SERVICE BULLETIN

TITLE: FUEL - INSPECTION FOR CHAFING OF ELECTRICAL CONNECTOR AND ASSOCIATED WIRING ON FUEL LINE

Model G36 Bonanza, Serials E-3630, E-3636 through E-3817, E-3819 through E-3834, E-3836 through E-3887, E-3889 through E-3896, E-3898 and E-3899.

View Looking Up and Outboard from Above Pilot's Rudder Pedals
Figure 1

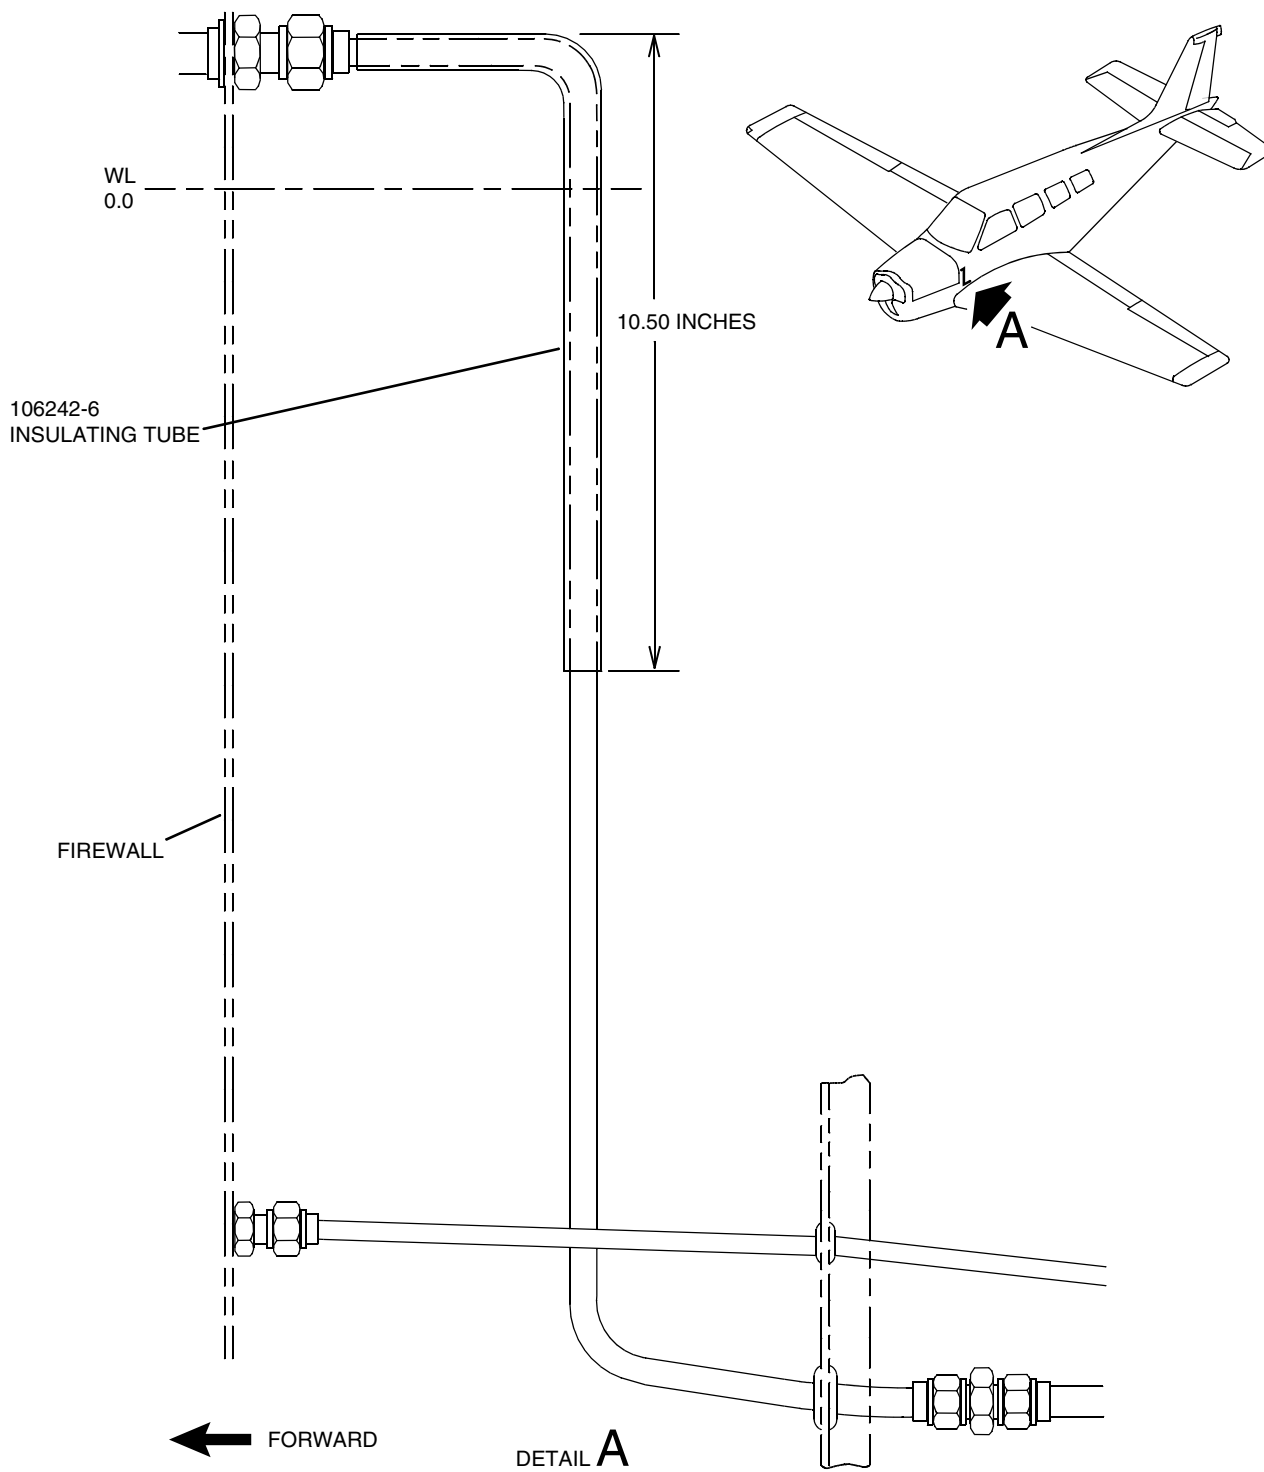
- (1) Remove all power from the airplane and disconnect the battery. Display warning notices prohibiting reconnection of airplane electrical power.
- (2) Gain access to inspection area, which is aft of the firewall and forward of the pilot's instrument panel on the left side. Refer to Figure 1.
- (3) Just aft of the firewall and forward of the instrument panel on the pilot's side, inspect fuel line P/N 36-920001-13, P60 / J60 electrical connector and associated wiring for damage as a result of chafing.
- (4) Make the following determinations:

AREA OF POTENTIAL CHAFING

IF:	THEN:
The fuel line, connector or associated wiring is damaged.	Replace fuel line if damaged. Replace or repair damaged wiring (Refer to AC 43-13-1B, Chapter 11). Replace connector if damaged. Ensure fuel line, electrical connectors and associated wiring are secure and have a minimum of 0.50-inch separation.
The fuel line has factory protective insulating tube properly installed (starting at the firewall and continuing for a minimum of 10.50 inches past the first bend in the fuel line). Refer to Figure 2. No damage to the fuel line, electrical connector or associated wiring.	Ensure fuel line, electrical connectors, and associated wiring are secure and have a minimum of 0.50-inch separation.
The fuel line does <u>not</u> have factory protective insulating tube properly installed and there is no damage to the fuel line, electrical connector, or associated wiring.	Install spiral wrap P/N HT1/2T on the fuel line in the location depicted in Figure 2. Ensure fuel line, electrical connectors, and associated wiring are secure and have a minimum of 0.5-inch separation. NOTE If fuel line is already protected with approved chafe protection, it is not necessary to add spiral wrap.
